**CHANGES: 04/14/2014**  
**REVISIONS TO REZONING CASE #Z05-32**

# HARMONY ROAD II REVISIONS

## REZONING SUBMITTAL

**HARMONY ROAD  
 DURHAM, NORTH CAROLINA  
 PROJECT NUMBER: SDP-12030**

SHEET: C-2

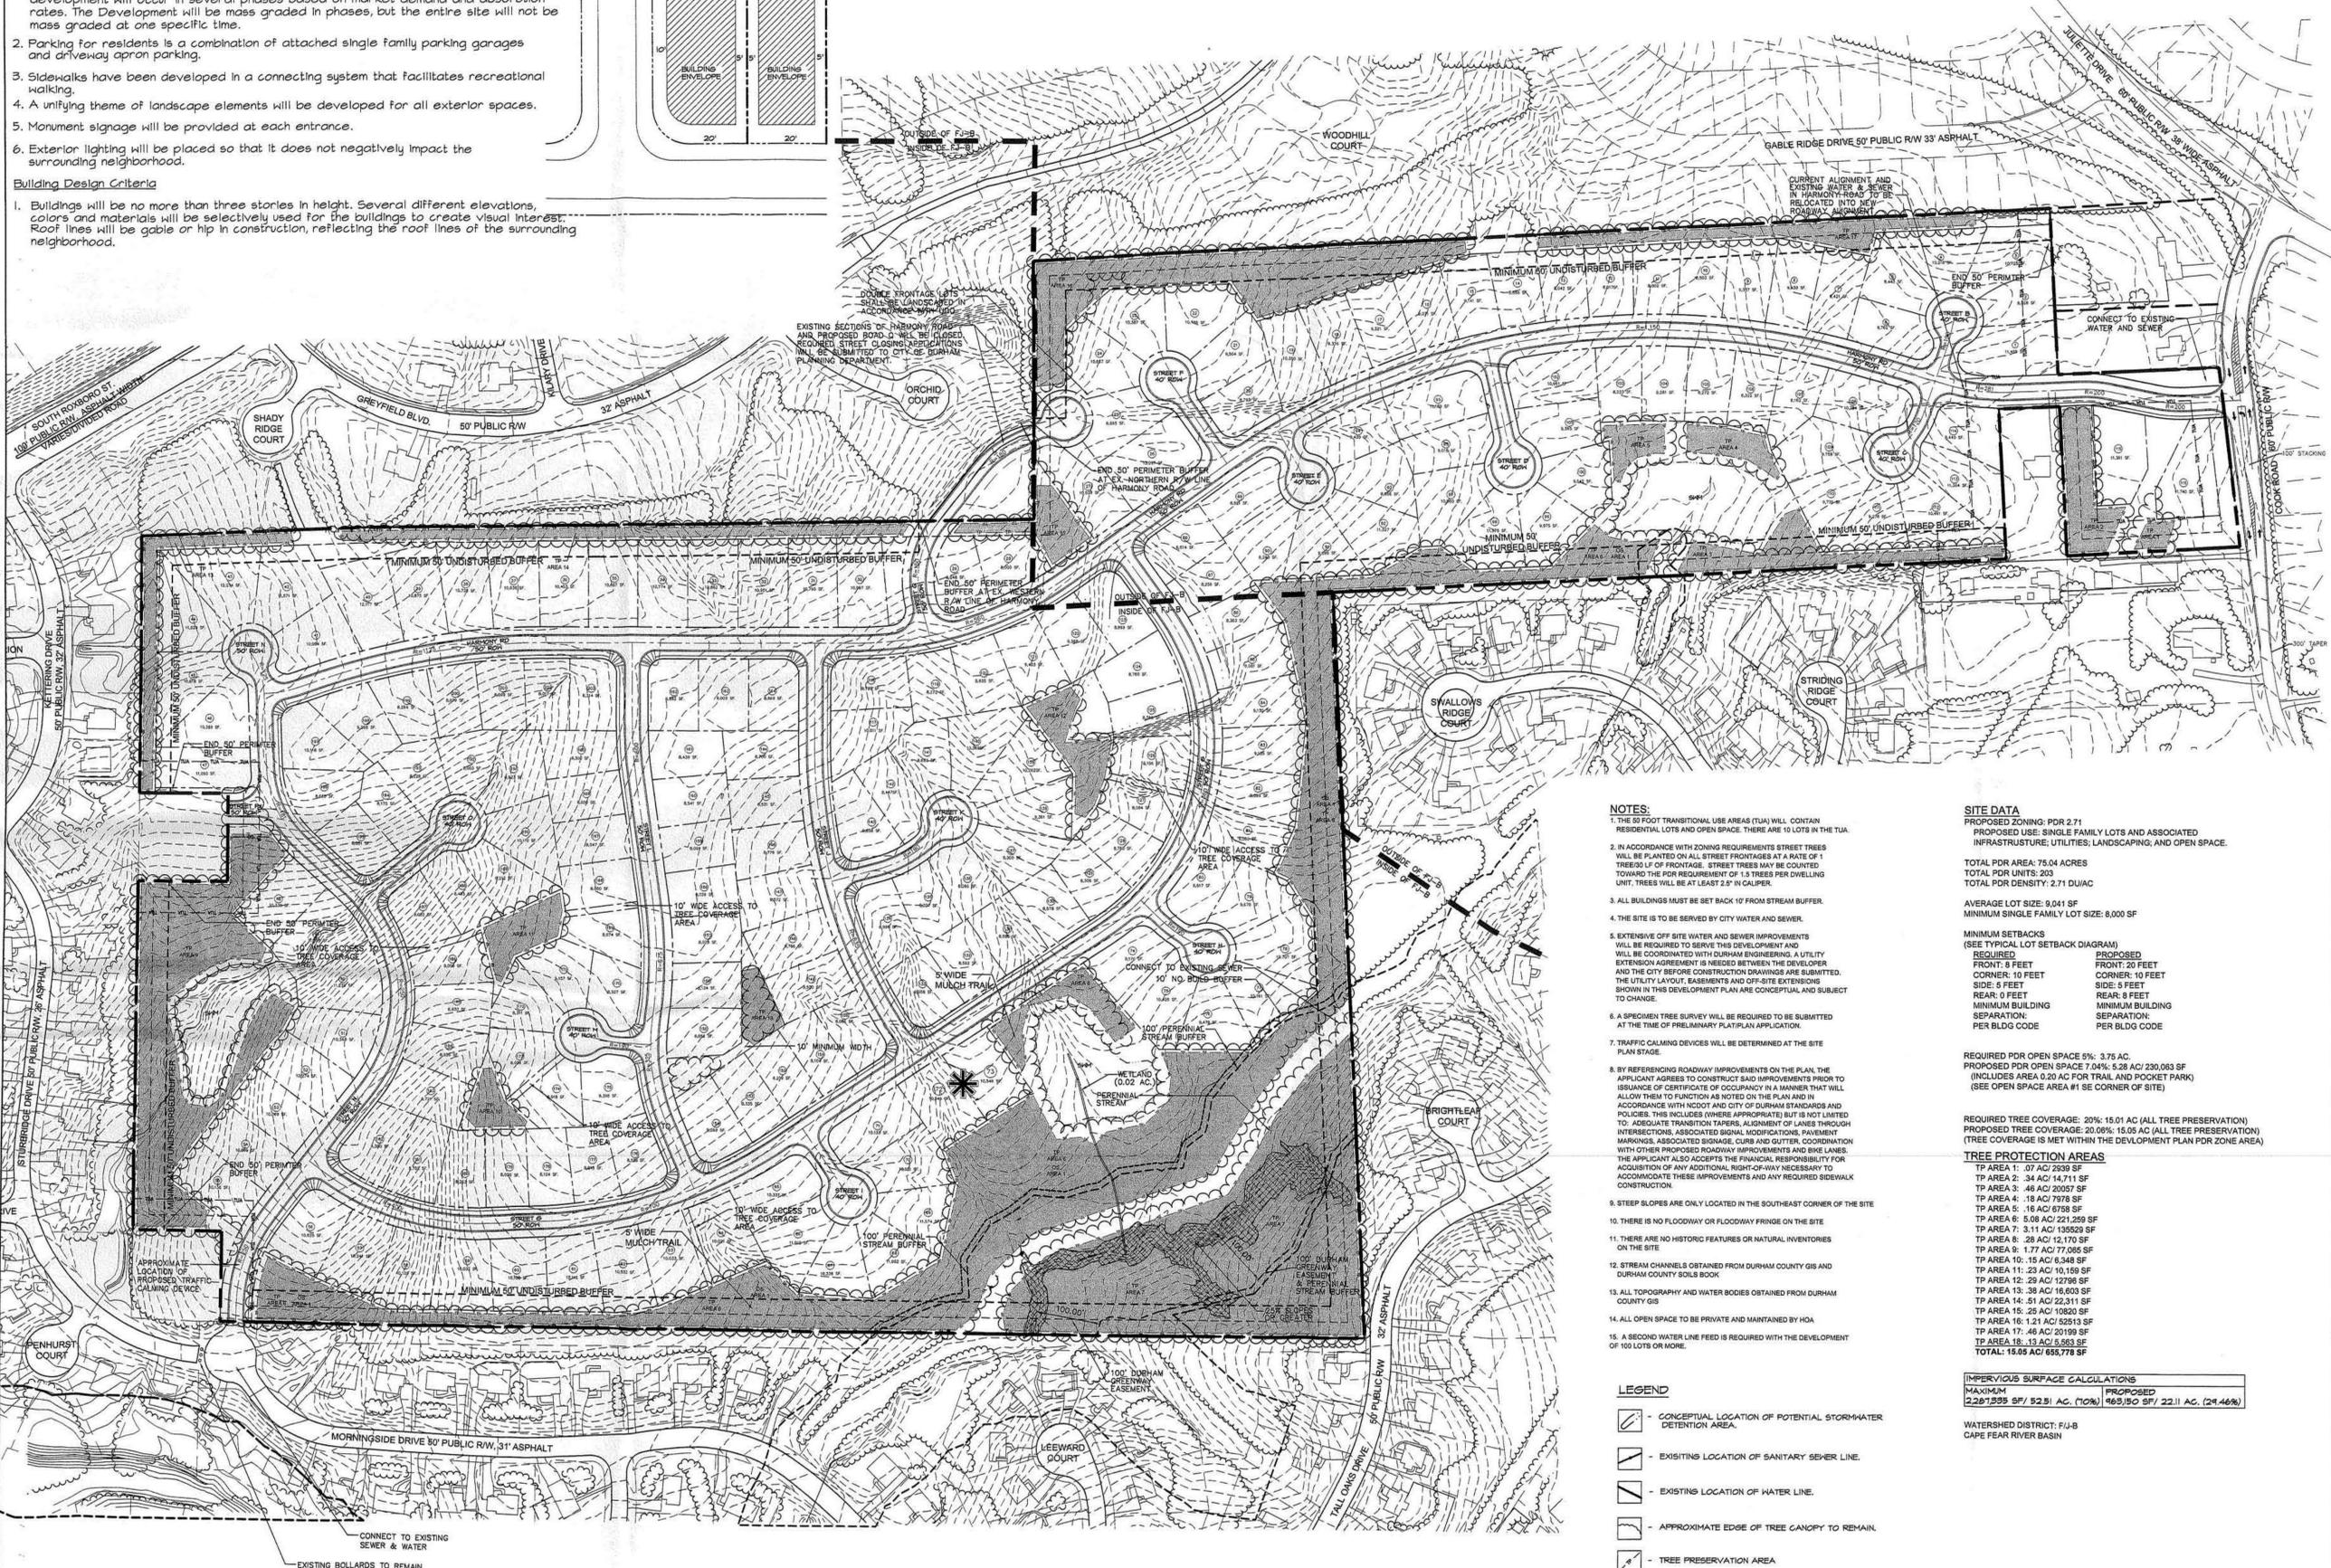
1. MODIFICATION TO THE TIMING MECHANISM OF CONDITIONS 12, 13 & 15 BELOW.
2. REMOVAL OF ORIGINAL TEXT COMMITMENT 12 REGARDING OFF-SITE TRAIL CONNECTIONS.
3. REMOVAL OF ORIGINAL TEXT COMMITMENT 18 REGARDING ON-SITE MULCH TRAIL.

12. PROVIDE A TRAFFIC-CALMING DEVICE APPROVED BY THE CITY OF DURHAM NORTH OF THE MORNINGSIDE DRIVE CUL-DE-SAC AT THE ENTRANCE TO HARMONY ROAD II PROJECT PRIOR TO THE FIRST CERTIFICATE OF OCCUPANCY ON KINNEY GLEN COURT

13. CIRCULATE A PETITION AMONG THE PROPERTY OWNERS ALONG MORNINGSIDE DRIVE SOUTH OF THE HARMONY ROAD II PROJECT AND, IF SUFFICIENT SIGNATURES ARE OBTAINED (75% OF AFFECTED PROPERTY OWNERS) AND THE CITY OF DURHAM ENGINEERING AND TRANSPORTATION DEPARTMENTS APPROVE, INSTALL SPEED HUMPS PER CITY OF DURHAM STANDARDS ON MORNINGSIDE PRIOR TO THE FIRST CERTIFICATE OF OCCUPANCY ON KINNEY GLEN COURT.

14. MINIMUM 16.58 ACRES (22.1%) TREE COVERAGE.
15. APPLICANT SHALL EITHER CONSTRUCT OR PROVIDE UP TO \$50,000 TOWARD THE COMPLETION OF THE SIDEWALK ALONG THE EAST SIDE OF COOK ROAD FROM THE INTERSECTION WITH HARMONY ROAD TO THE NORTHERN ENTRANCE OF SOUTHWEST ELEMENTARY SCHOOL. CONSTRUCTION OF THE SIDEWALK OR PAYMENT-IN-LIEU SHALL BE PROVIDED PRIOR TO THE FIRST CERTIFICATE OF OCCUPANCY ON KINNEY GLEN COURT.
